Subject: PC 17-2025: Abbey Ridge LLC; Review of Preliminary Plat for Abbey Ridge Subdivision No. 2

PRELIMINARY PLAT CONDITIONS

Abbey Ridge Subdivision No. 2

PC 17-2025

PRELIMINARY PLAT

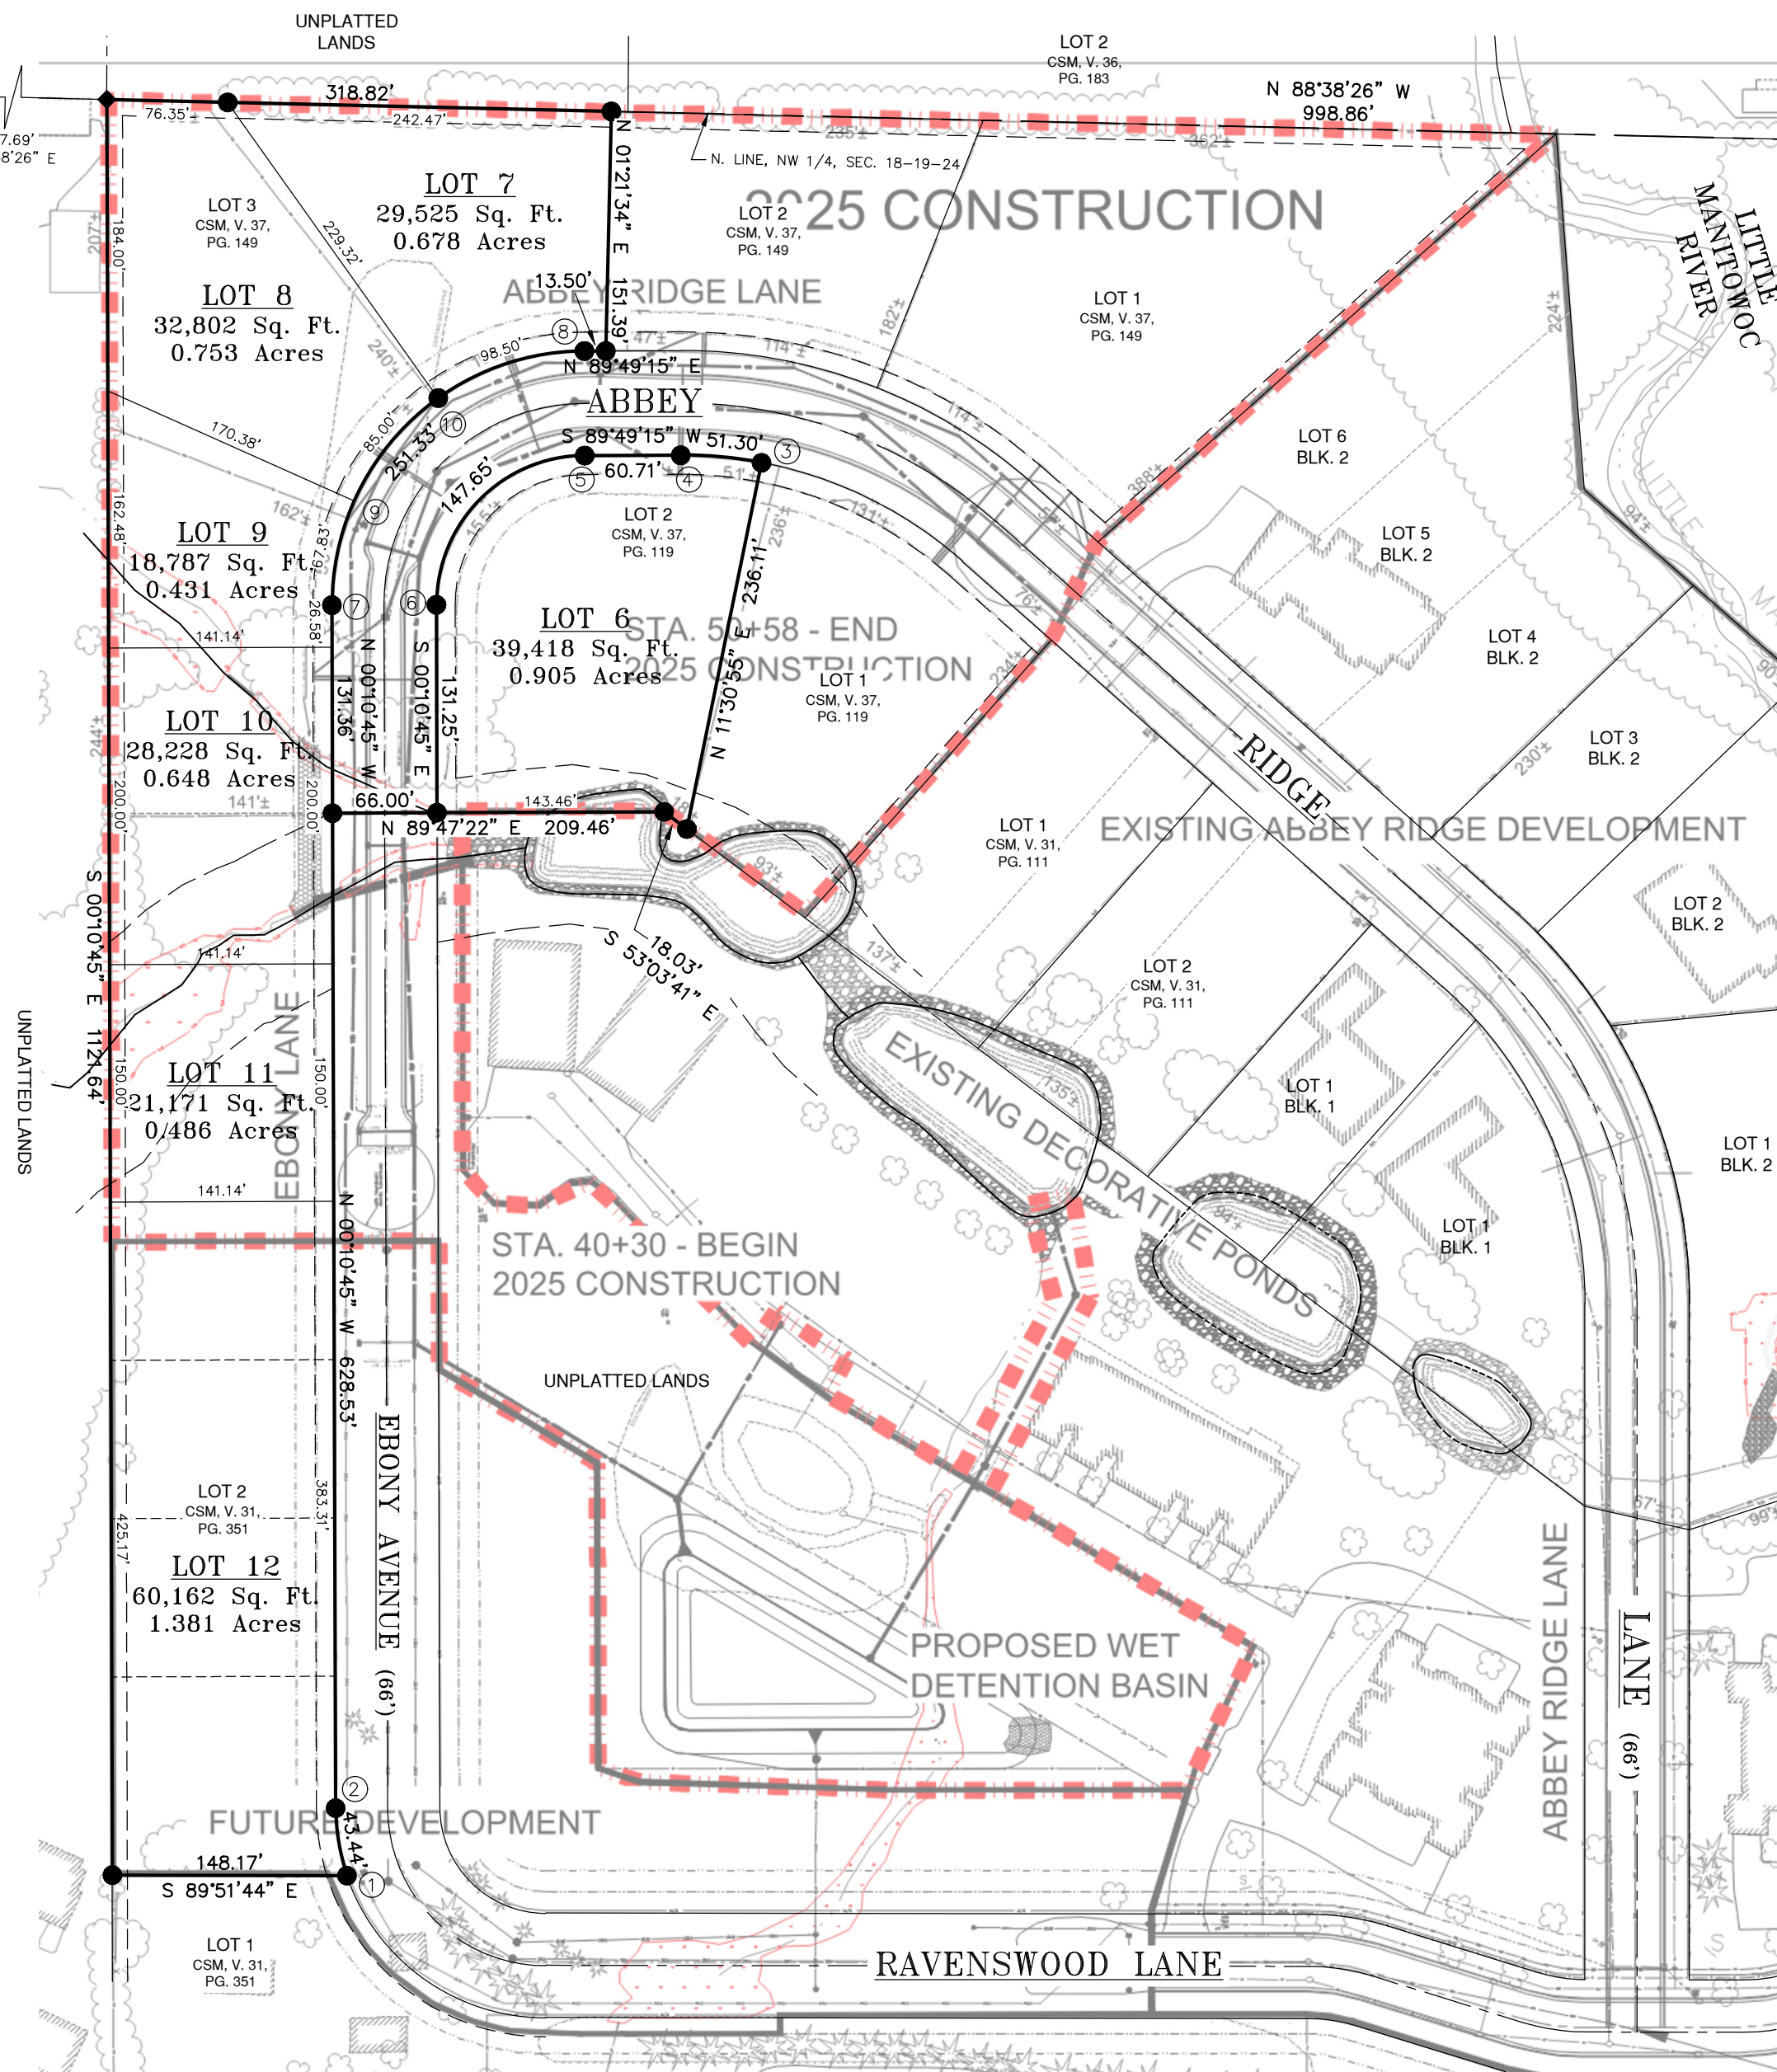
1. MPU Water prefers that the proposed watermain shown underneath the reinforced storm culvert (approx. STA 43+00 to 43+60) be installed at approximately 18" below the bottom of the storm culvert. Insulation should be installed between the storm culvert and watermain to prevent frost from affecting watermain. Additionally, If the road is not going to be constructed in 2025, Mammoth will have to provide 6' of cover in this area to ensure we have no frost issues prior to the road construction.

1. No issues with proposed plan. Contact WPS New Service Installation (800-242-9772) to apply for gas service.
2. WPS has easement for facilities north of proposed wet detention basin.
